Appeal by Boningale Developments Ltd

Masterplanning Written Questions Response

Patshull Road, Albrighton, Shropshire

LPA Reference: 24/02108/OUT

IMAGE 1: Labelled Areas (based on Inspector Written Questions mark-up).

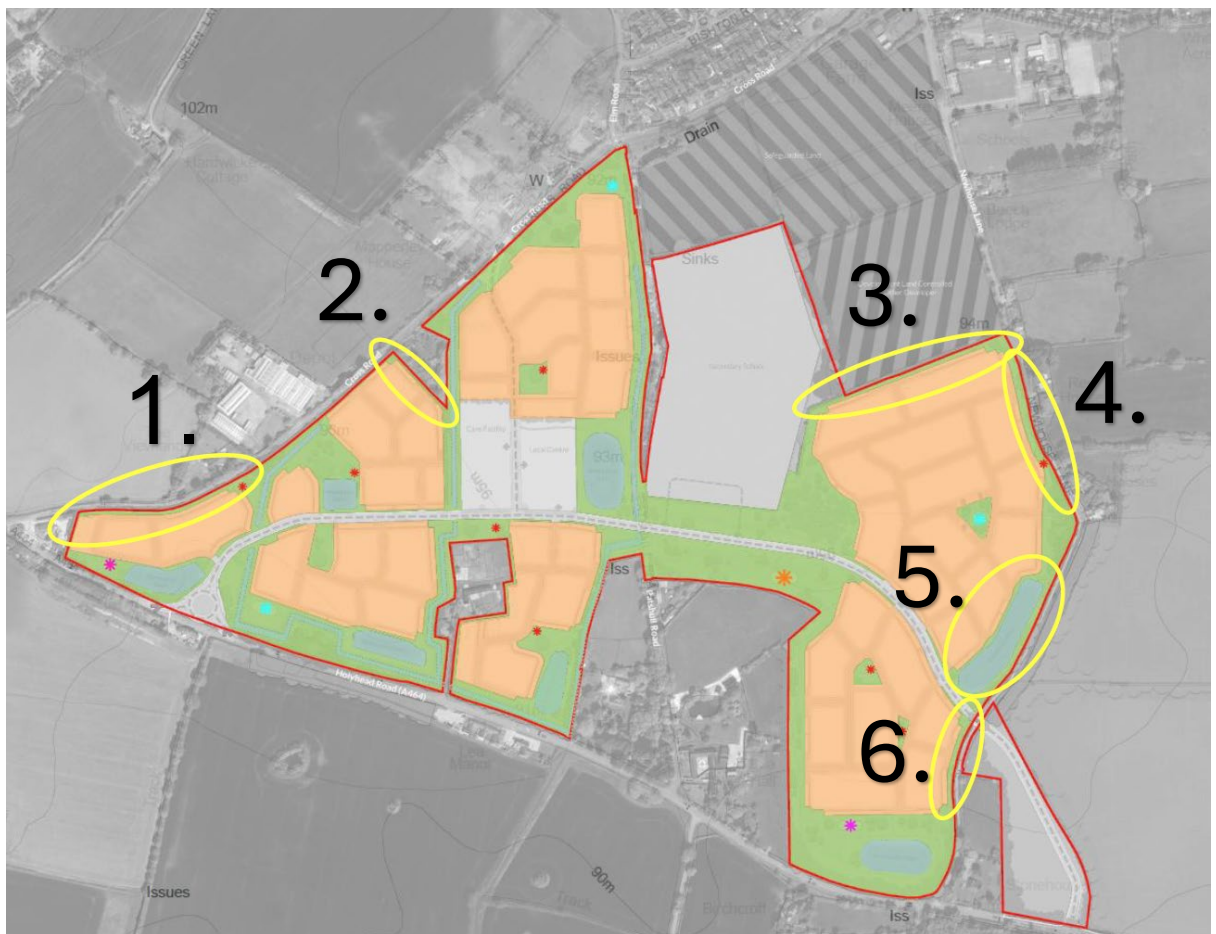
1. Question 1 – Dimensions of Usable Public Open Space

1.1 The distances from the proposed residential areas to the site boundary as identified within the written questions area and included within **Image 1** below are as follows.

Identified Area	Distance to Boundary
1	5m – 7m
2	4m – 5m
3	6m – 9m
4	12m – 13m
5	39m – 48m (including basin) 12m – 14m (excluding basin)
6	8m – 9m

IMAGE 2: Illustrative Sections through Usable Public Open Space

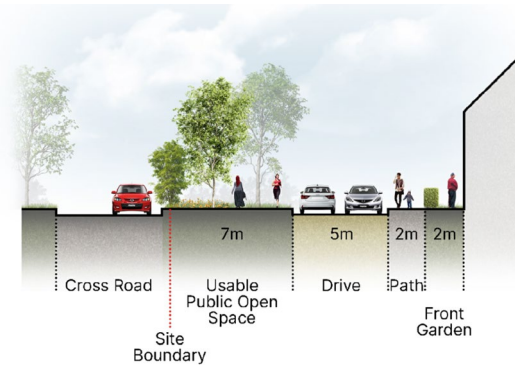
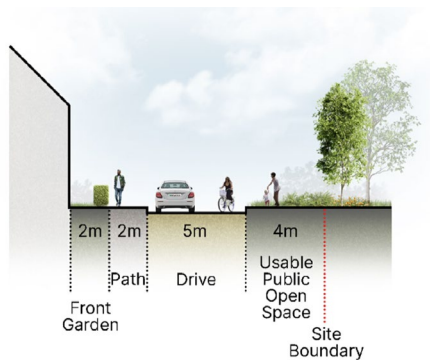
2. Question 2 – Usability of Usable Public Open Space

2.2 The areas identified within the written questions are usable areas of public open space as part of this wider network. They provide green areas and linking green corridors between larger areas of public open space and play areas. They provide space for transition from the edge of development and the land beyond the site boundary, with space for movement, recreation and amenity. It is this variety of spaces which will give users choice in what spaces they wish to use and how to use them. Indicative site sections at some of the areas identified (two of the narrower areas and the one with the attenuation basin) have been included to further illustrate the widths and usability of the spaces (**Image 2**).

2.3 As a point of clarity, it is accepted that the attenuation basins may not be considered usable open space by the Council. However the land would be dry for the majority of the year and it would be practical for most people to be able to use these areas if they wished to do so. Surrounding all attenuation basins there would be an area of public open space that would be dry all year around and accessible to the public.

Image 5 – Illustrative Landscape Masterplan Extract (from CD11.17).

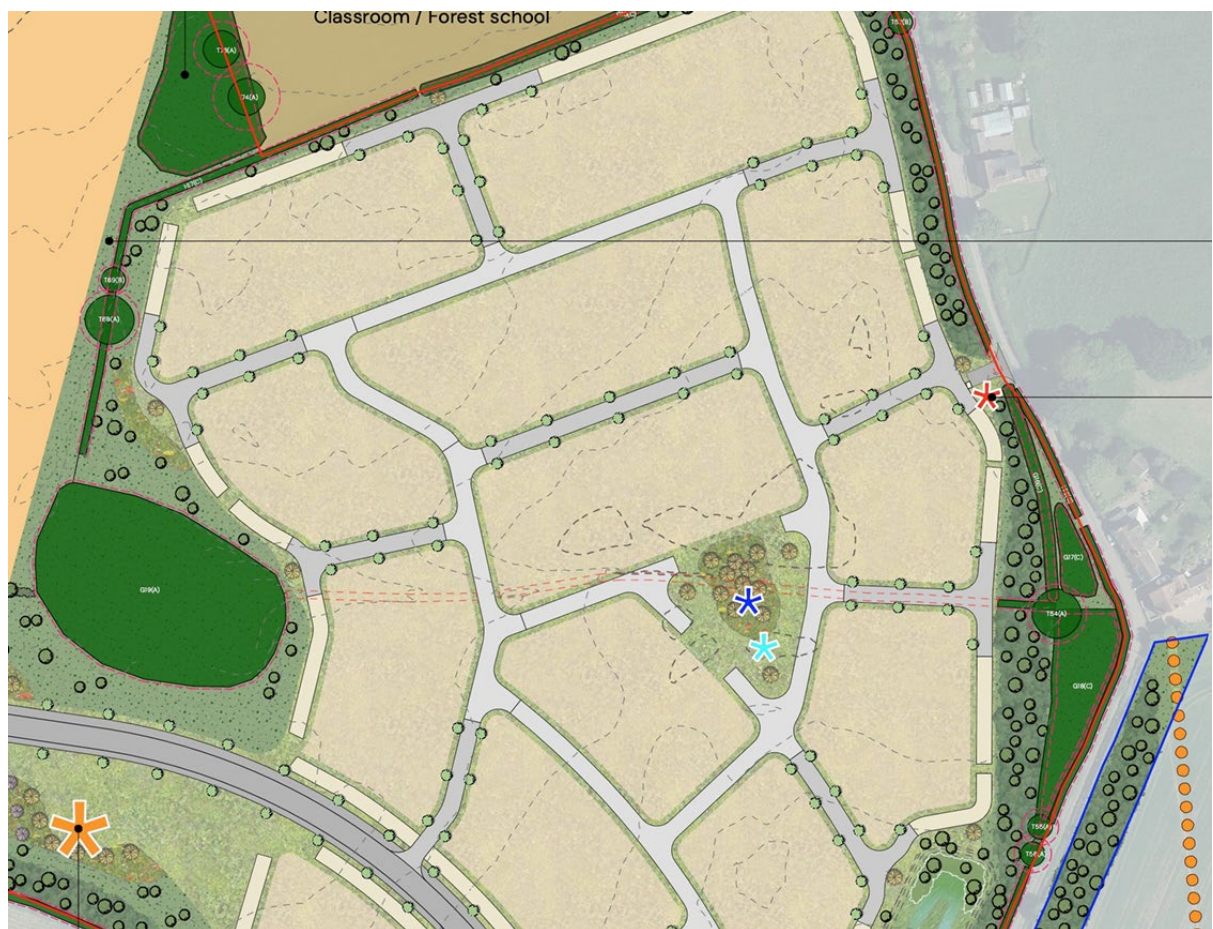
5 Question 5 – Green Route through Development

5.1 The question raises the potential to ‘break up’ the proposed development on the north-eastern part of the site (as identified in **Image 4**).

5.5 In addition, the Illustrative Landscape Masterplan (**CD11.17**) also shows the potential for green streets, connecting the green edges of the development with the centrally located green space and play area (**Image 5**).

5.6 Therefore, in summary, whilst the detail of the streets and development proposals will be determined at the reserved matters stage, the outline design proposals can deliver and anticipate green streets and planting within this identified area and across the development. This could include a defined green route through the residential development proposed at the north-east part of the site. The Guiding Design Principles and Contextual Responsiveness Document (**CD6.4**) and Illustrative Landscape Masterplan (**CD11.17**) provide further supporting information to guide the detailed design at the reserved matters stage.
